July 9, 2015

**BOARD OF COUNTY COMMISSIONERS
ORANGE COUNTY, FLORIDA**

**ADDENDUM NO. 2 / IFB NO. Y15-786-J2
ORANGE COUNTY LANDFILL WESTERN BORROW AREA ELECTRICAL SYSTEM**

ELECTRICAL
SITE PLAN

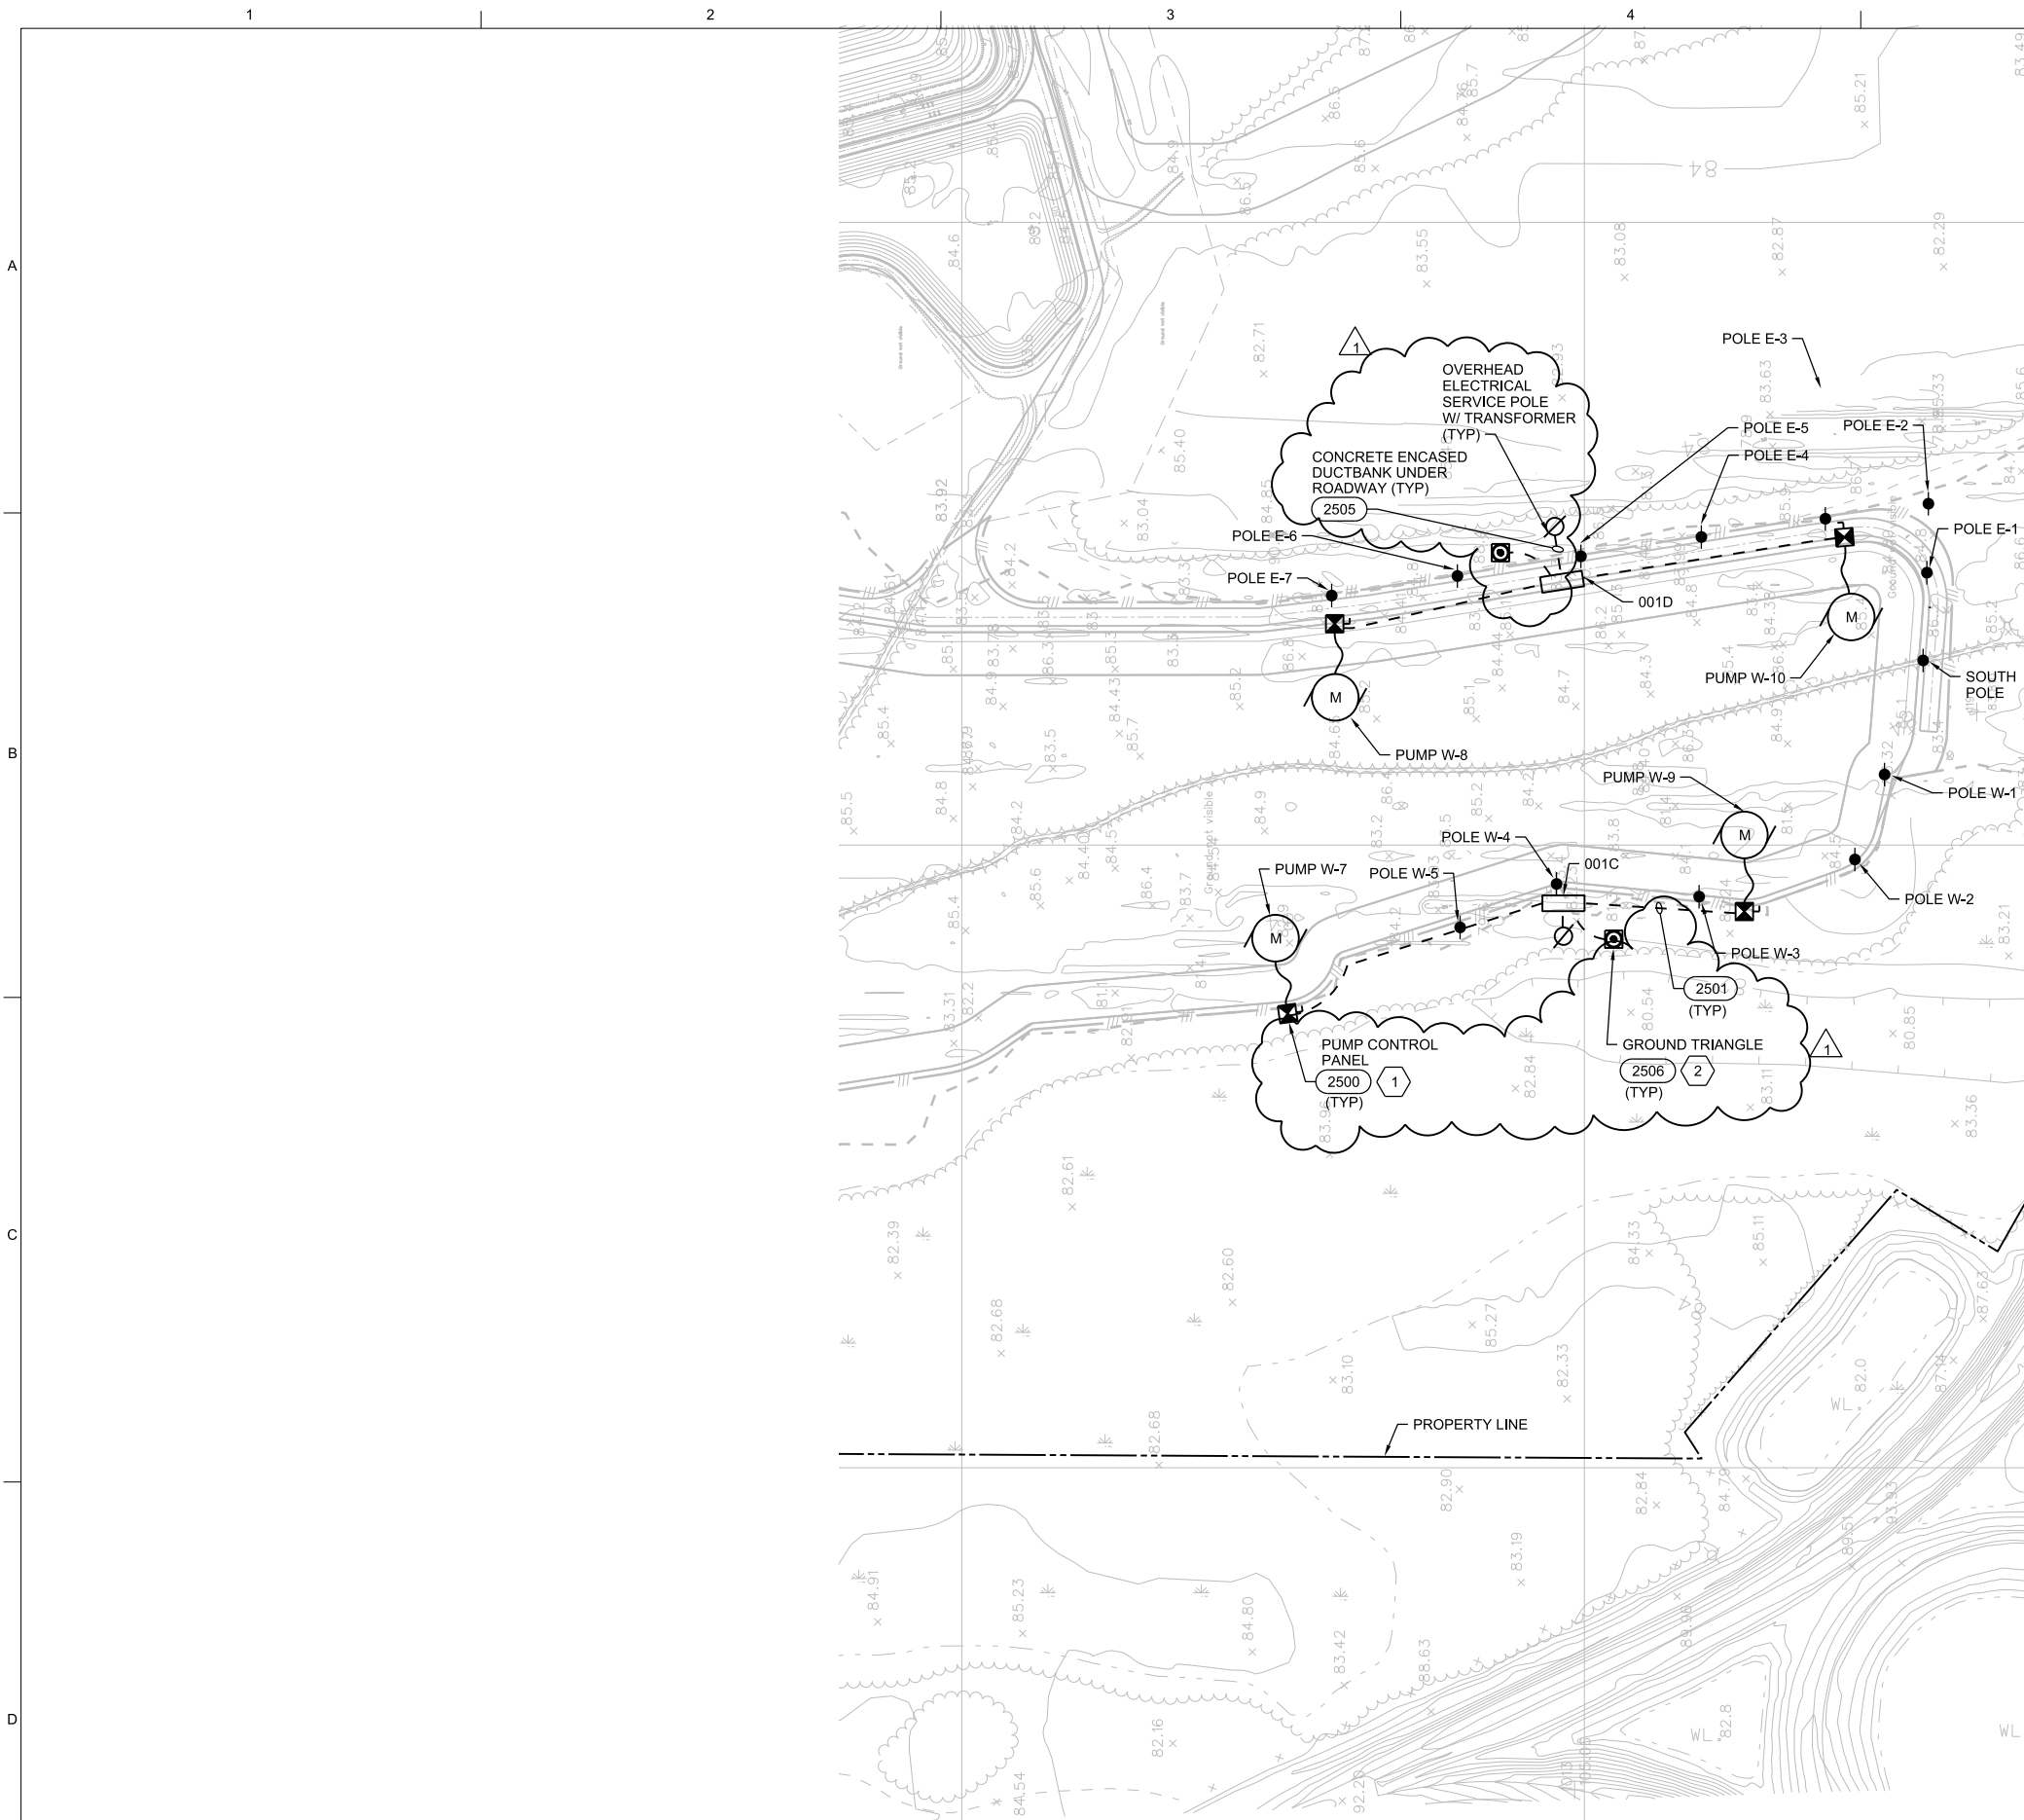
QUESTION 12. On sheet E-001, hex note 3, it shows concrete encased duct bank under roadway. Is all underground conduit to be concrete encased or only the conduits under the roadways?

QUESTION 13. On sheet E-001, there are (10) pumps shown to be installed. Are we doing all of the electrical work shown on this page? Please clarify the areas and limits of our scope of work.

Response: See Response to Question 5.

Response: Scope is for Panels 001C and 001D. See revised drawings.

1. COORDINATE WITH THE OWNER TO FIELD LOCATE THE PANEL BOARDS AND STARTERS, ADJACENT TO THE ROADWAY, 10 FEET FROM THE EDGE.
2. FIELD LOCATE GROUNDING TRIANGLES NEXT TO THE PANEL BOARDS AND OUT OF THE ROADWAYS.
3. COORDINATE FIELD LOCATION OF THE DUCT BANK AND HAND HOLES WITH THE OWNER, ADJACENT TO THE ROADWAY AT THE TOP OF THE EMBANKMENT.

ELECTRICAL
ONE-LINE DIAGRAM

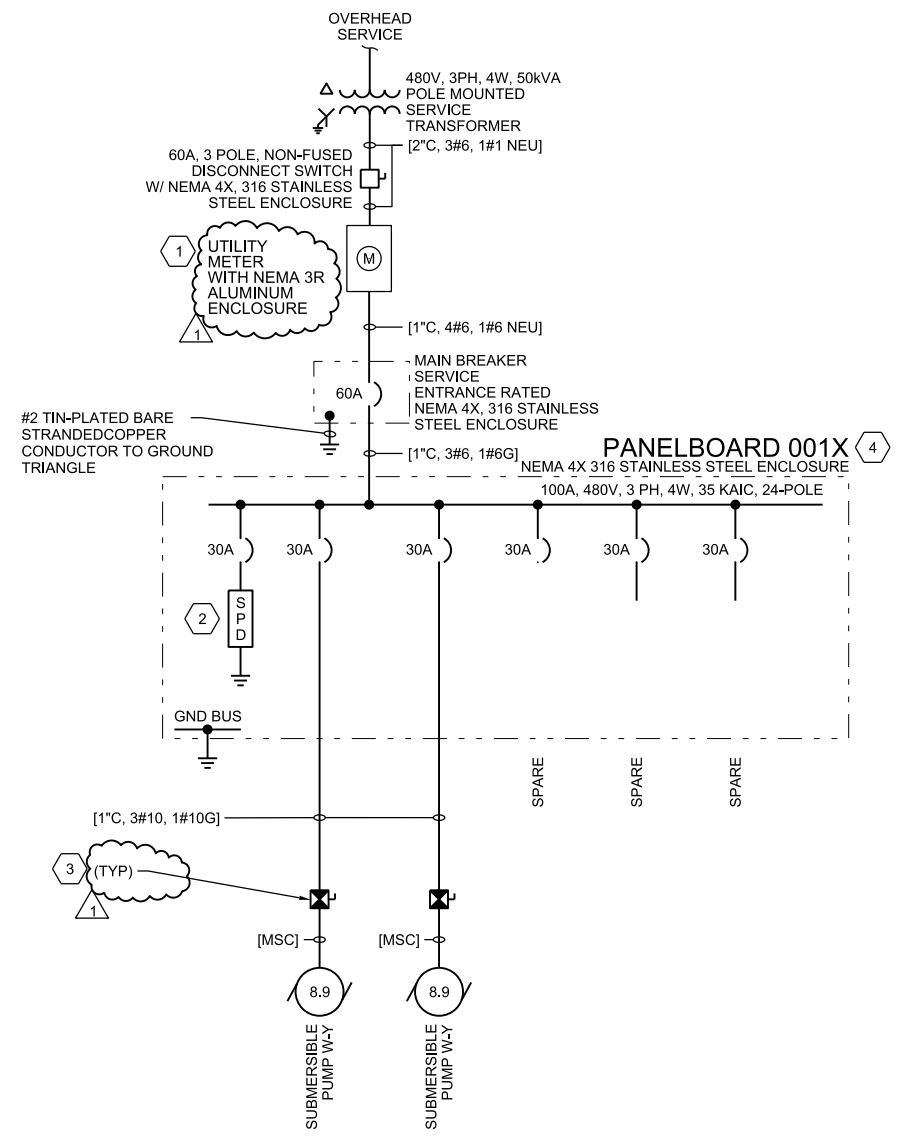
QUESTION 4. Will the meter base be required to be stainless steel 4X?

QUESTION 10. The new Pump Package viewed at the Pre-Bid Conference contained a pump controller in a NEMA 3R enclosure for each pump. Are these controllers to be used in lieu of or in addition to the Combination Motor Starters indicated on Sheet 4, or not at all? If they are in addition to the Combination Motor Starters, are they to be installed adjacent or integral to the pump or do they get mounted on the rack with the with the Combination Motor Starter?

QUESTION 14. Who provides the size 1 starters (hex note 4) on sheet E-002?

Response: Meter base shall be NEMA 3R aluminum. See revised Drawings.

Response: Pump controllers provided by Owner will be used. See revised drawings.

Response: See response to Question 10.

1. CONTRACTOR SHALL COORDINATE WITH POWER COMPANY FOR ALL SERVICE REQUIREMENTS.
2. PROVIDE CATEGORY C3, 10-MODE, 120 KA PER MODE SURGE PROTECTIVE DEVICES (SPD) INSIDE THE PANELBOARD ENCLOSURE OR IN A SEPARATE NEMA 4X STAINLESS STEEL ENCLOSURE WITH CONNECTING CONDUCTORS MAXIMUM OF 12" LONG.
3. PUMP CONTROL PANEL AND PUMP PROVIDED BY OWNER, INSTALLED BY CONTRACTOR.
4. SQUARE D NF PANELBOARD WITH BOLT-ON CIRCUIT BREAKERS OR APPROVED EQUAL.

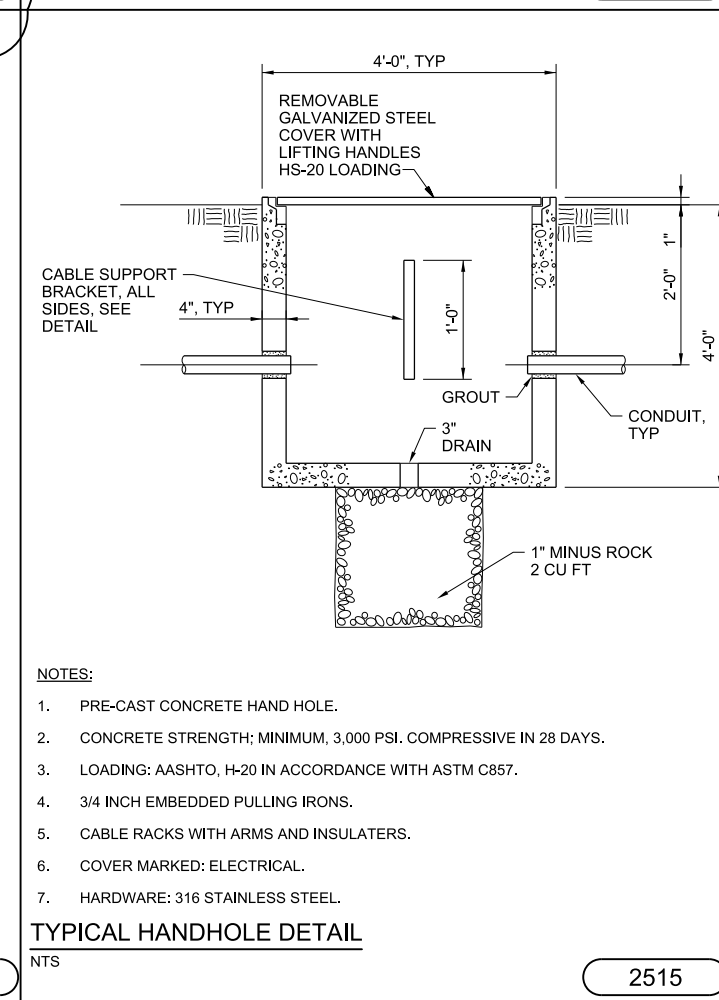
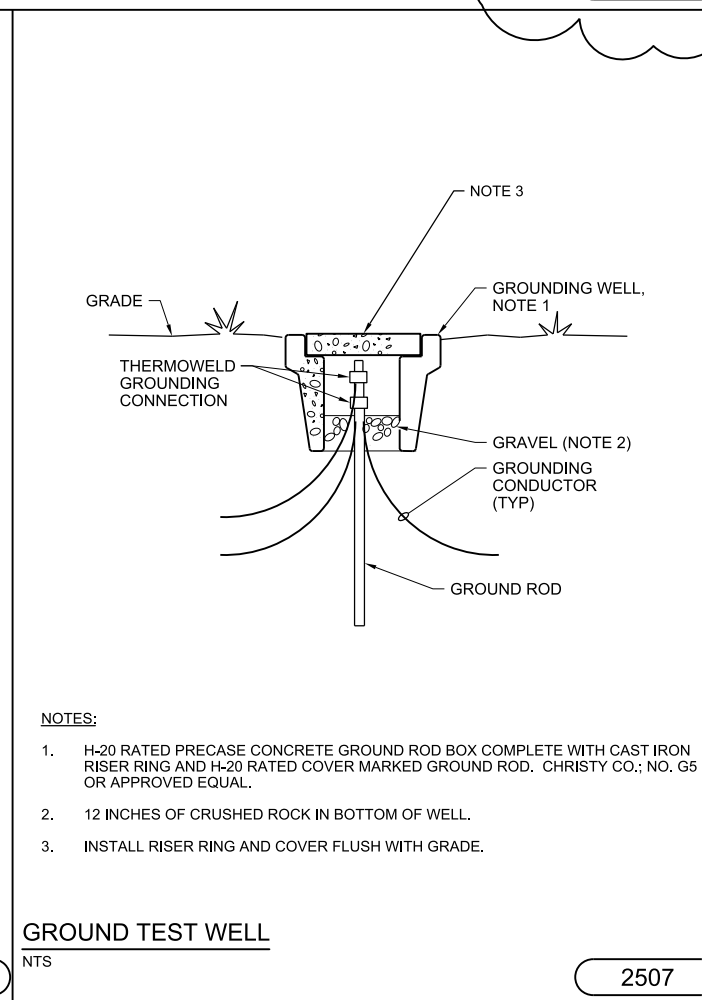
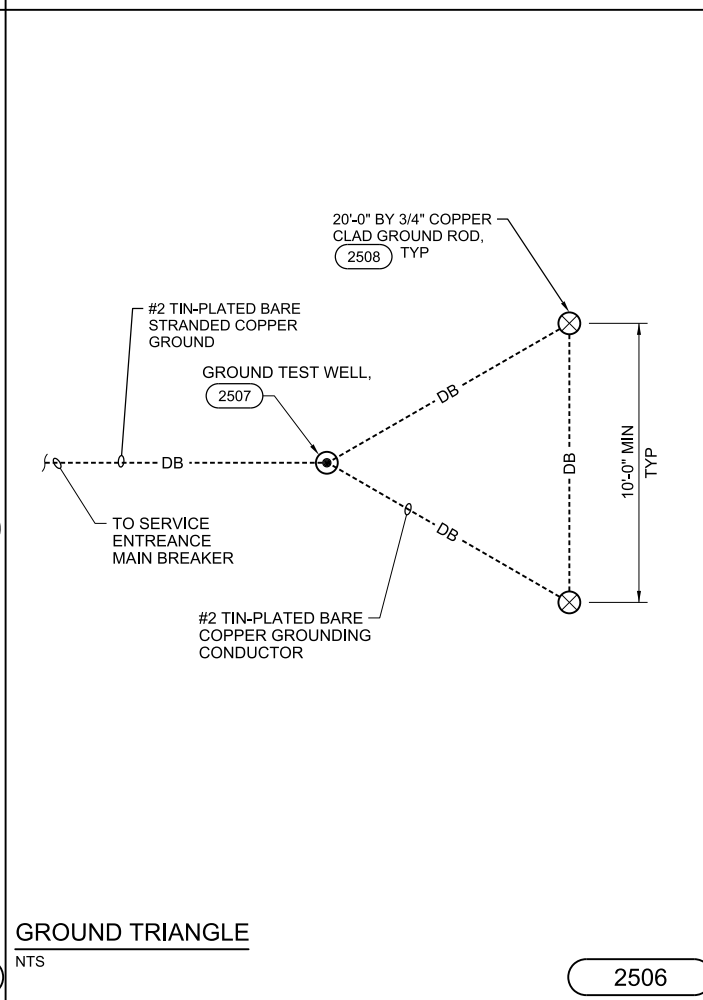
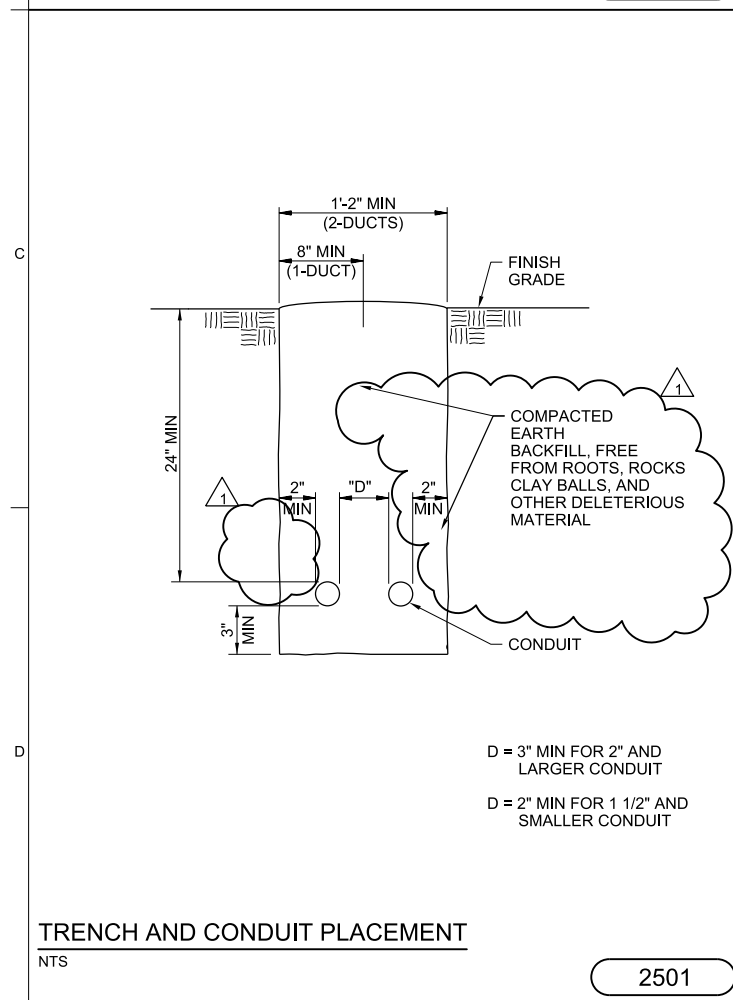
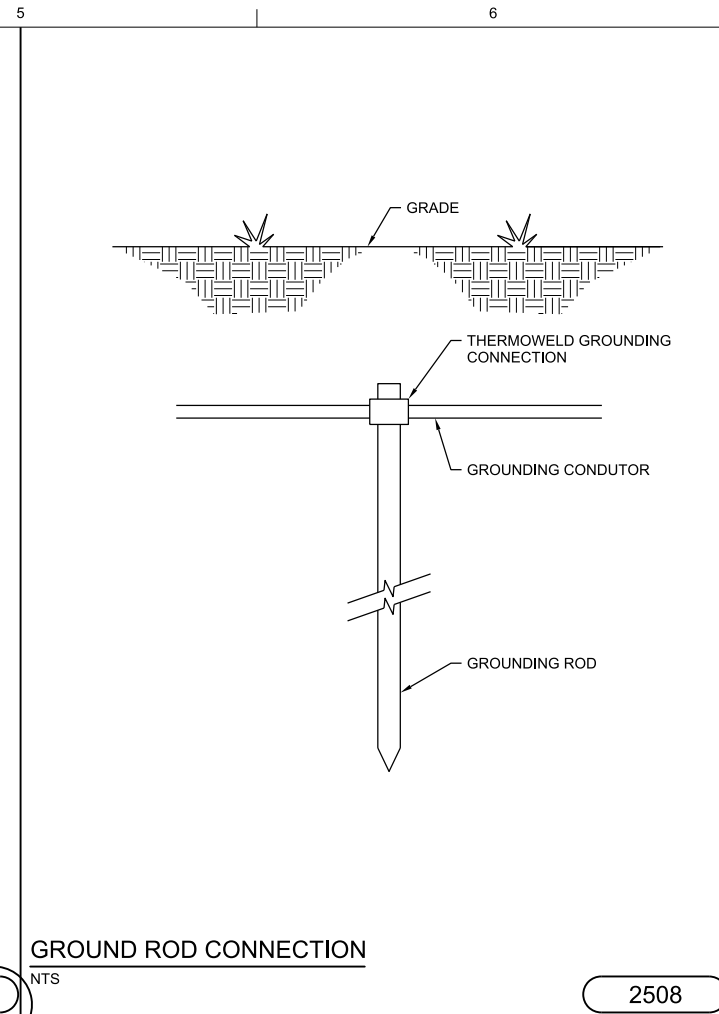
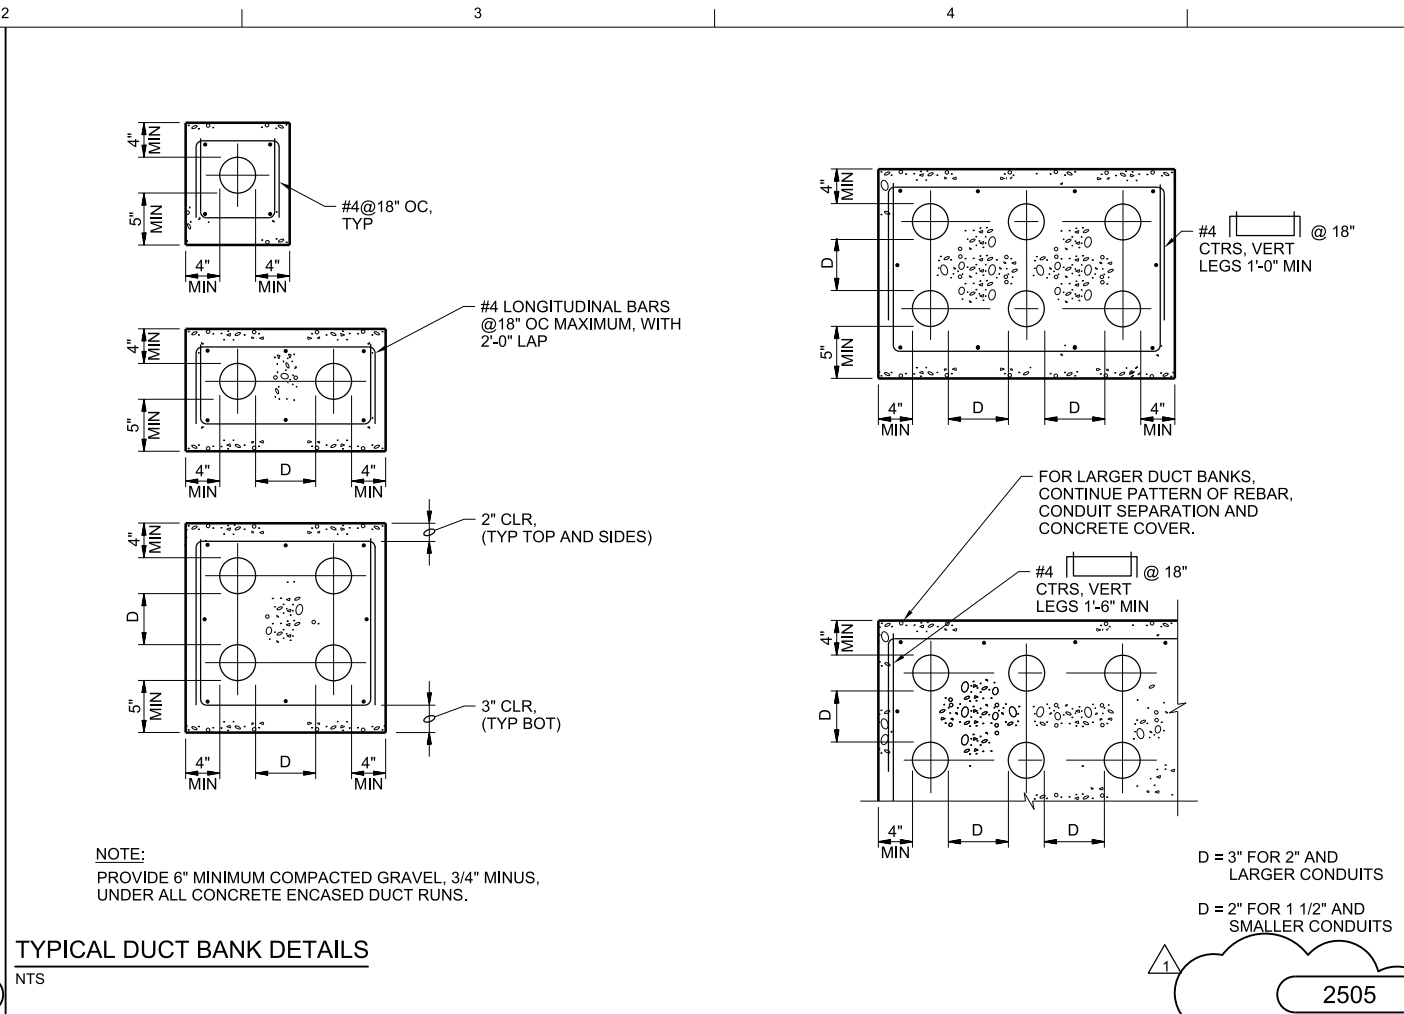
QUESTION 5. Is there any duct bank required in this project?

QUESTION 7. Please verify the underground conduits reflected on Sheet 3 will be installed as per Detail 2501 on Sheet 5 and define the type of material required for "Compacted Bedding and Pipe Zone Material"

Response: Underground conduits shall be installed per Detail 2501 unless they are under a roadway. Conduits under roadways are required to be concrete encased per Detail 2505. Please refer to General Electrical Requirement Number 8 on Sheet 1 of 5.

Response: See response to Question 5. Material removed from the trench can be used for both Compacted Earth Backfill. See revised drawing.
